ERCOT Batch Load Study Process
Withdrawal Risks

3/30/2026

CCR's Concern

Batch Study: Refinement Study

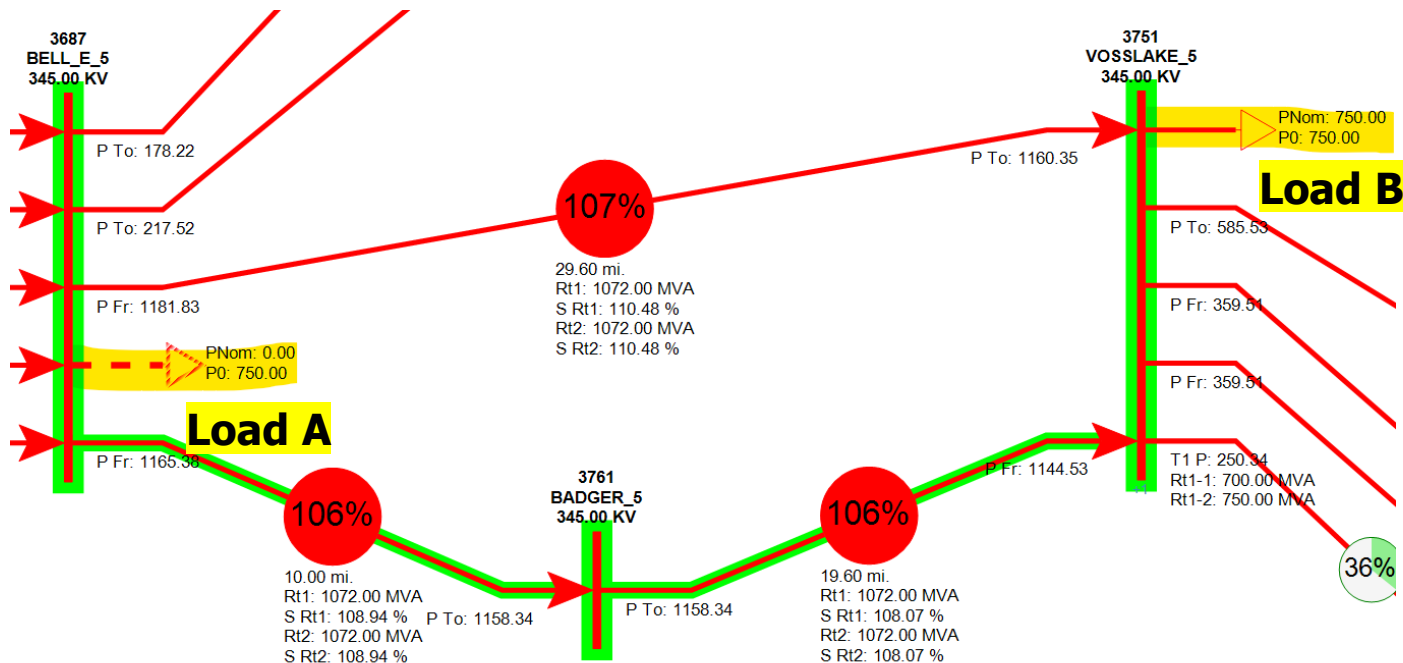
- New overload caused by Load A dropping

1. Will the Refinement Study identify scenarios like this? And propose new Transmission?
2. Who will securitize these upgrades? Load A or B?
3. How will ERCOT serve the 750 MW in 2028 with a base case overload?

- ERCOT can no longer guarantee 750 MW for Load B in 2028, as a network upgrade is now required.
- Assuming a 3-year upgrade timeline, the LCP should be updated.
- Load B executed an IA based on the assumption that 750 MW would be available in 2028, which is no longer feasible.

Batch Study: ERCOT proposal / Refinement Study

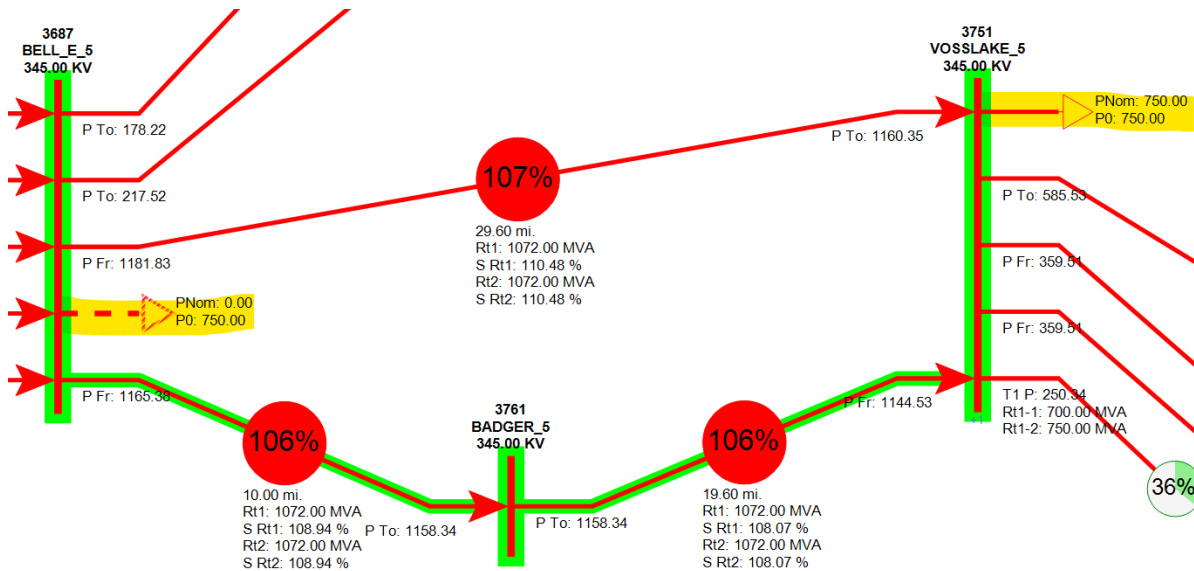
- Loads should be aware that executing an IA with “firm” deliverability may still carry risk if network upgrades are required to serve that load. If these conditions happen in real time—and no generation solution exists—ERCOT may need to declare a transmission emergency and curtail load to maintain system reliability.

Reduced Voss Lake 345 kV Load Serving Capacity: 375 MW

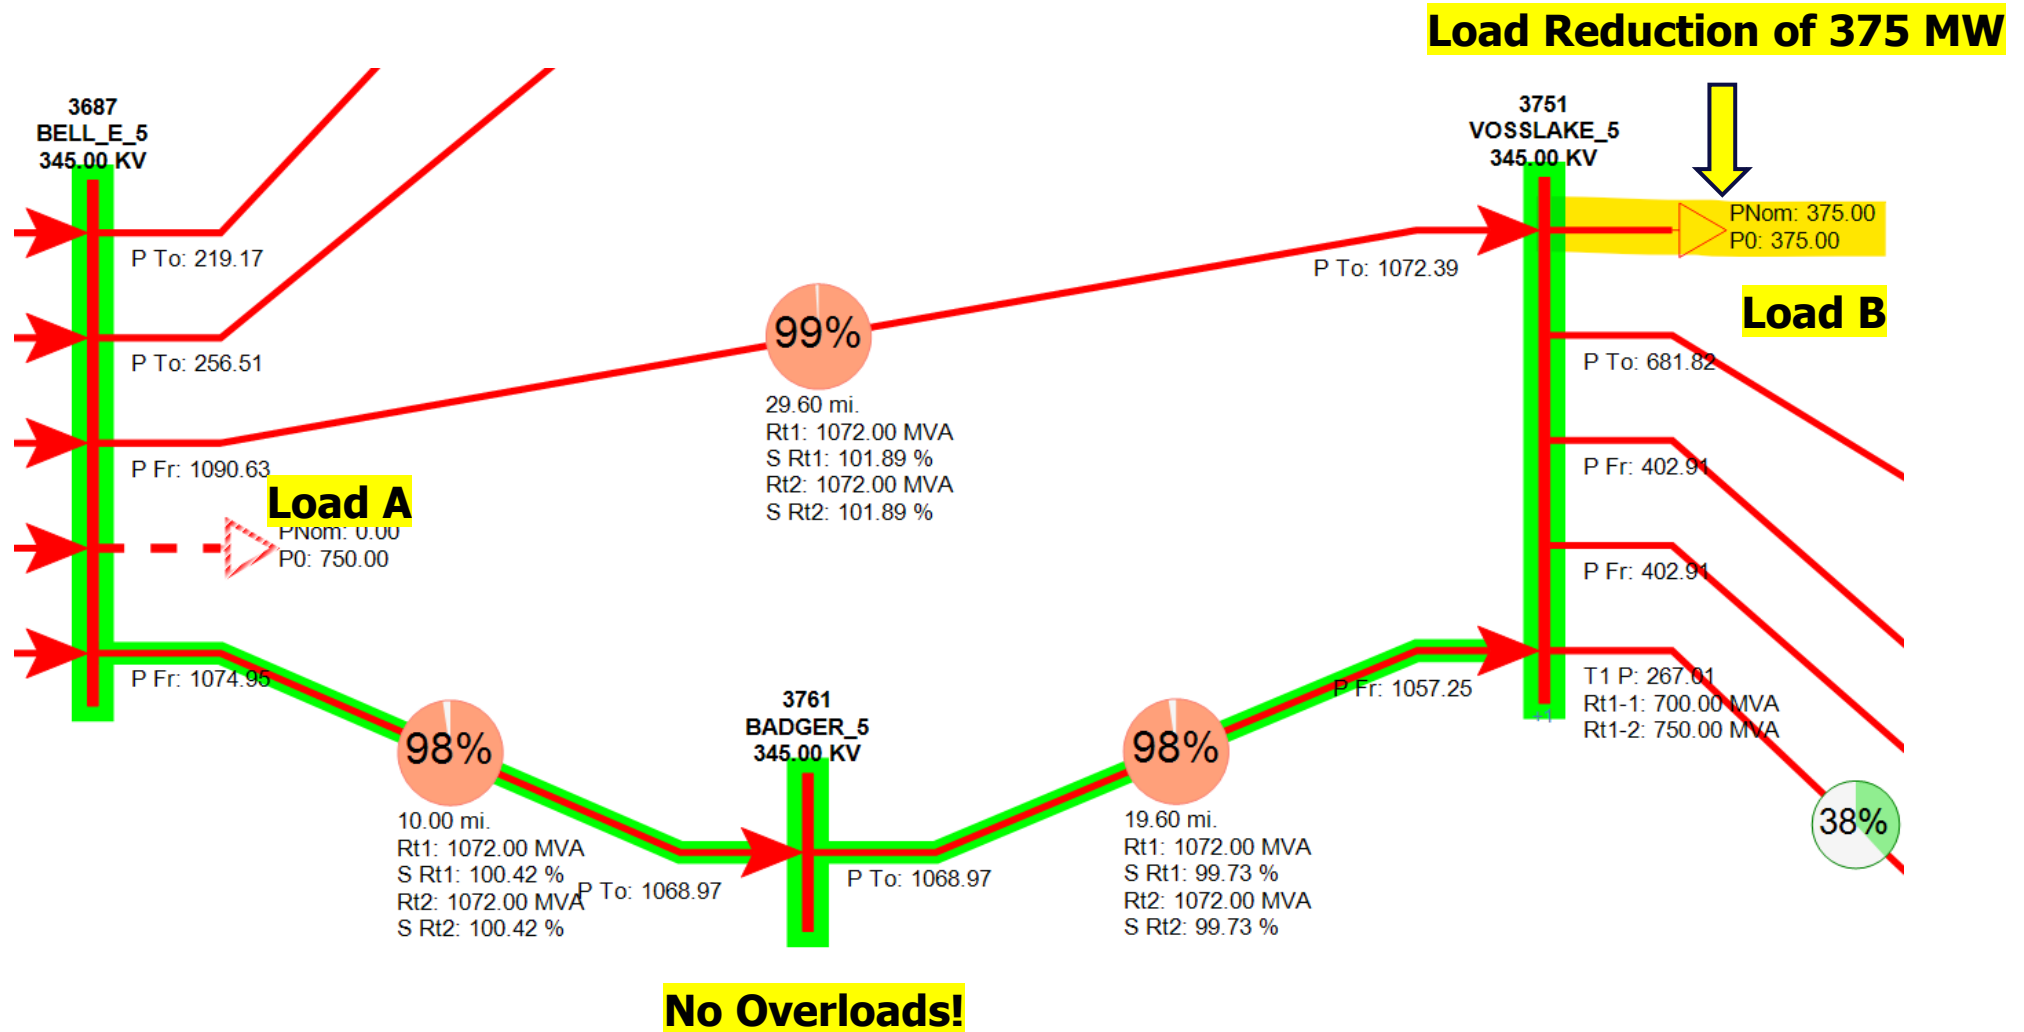
This can only be known after the refinement study, after Load B executes an IA and commits
